SUPPLEMENTARY COUNCIL ASSESSMENT REPORT

Panel Reference	PPSSNH-515
DA Number	eDA0223/24
LGA	Ku-ring-gai
Proposed Development	Demolition of existing structures, construction of a mixed-use development
Street Address	7-9 Merriwa Street, Gordon
Applicant/Owner	Applicant: Meccone Owner: Wei Dong Chen
Date of DA lodgement	28/06/2024
Total number of Submissions	20 total submissions (to original notification)
Total Number of Unique Objections	18 unique objections (to original notification)
Recommendation	Refusal
Regional Development Criteria - Schedule 6 of the SEPP (Planning Systems) 2021	General development over \$30,000,0000.00
List of all relevant s4.15(1)(a) matters	<ul style="list-style-type: none"> • SEPP (Planning Systems) 2021 • SEPP (Housing) 2021 • SEPP (Biodiversity and Conservation) 2021 • SEPP (Transport and Infrastructure) 2021 • SEPP (Resilience and Hazards) 2021 • SEPP (Sustainable Buildings) 2022 • Ku-ring-gai Local Environmental Plan 2015 • Ku-ring-gai Development Control Plan • Ku-ring-gai Contributions Plan 2023

Figure 1: Maximum height variation shown as “2490mm above building height plane” in the SW corner (source: Clause 4.6, revision C Mecone 2025).

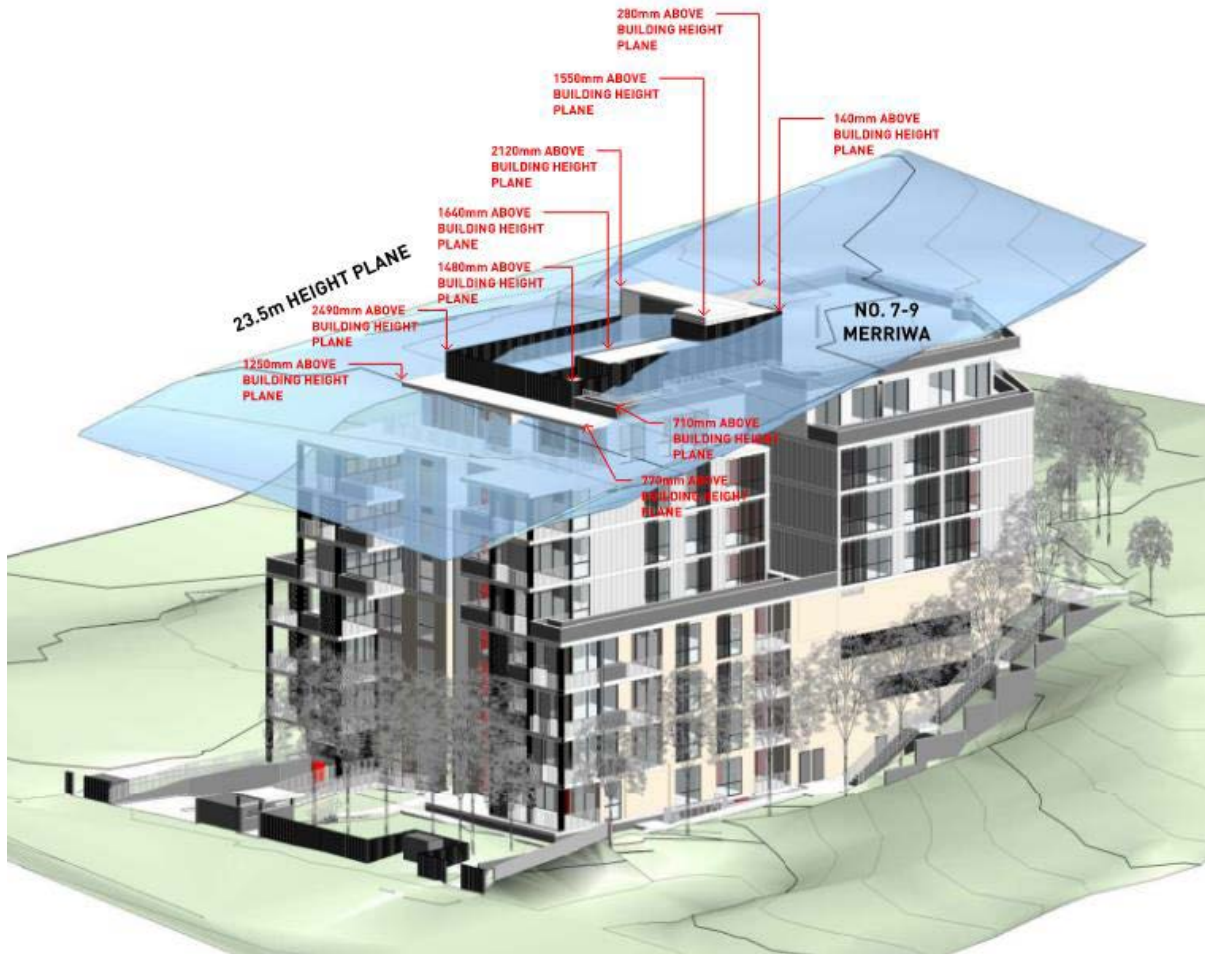
Using extrapolated ground levels, the height is proposed to reach a maximum of 25.99 metres. If approved, this would constitute a 2.49 metre / 10.6% variation to the 23.5 metre numerical standard, as can be seen in **Figure 1** below.

Extrapolating the ground levels is an appropriate method to measure the proposed building height in this instance, as the existing commercial building and basement has been developed from boundary to boundary, having existing deep excavation in the side setbacks to accommodate driveways resulting in existing ground levels that do not relate to the adjoining properties.
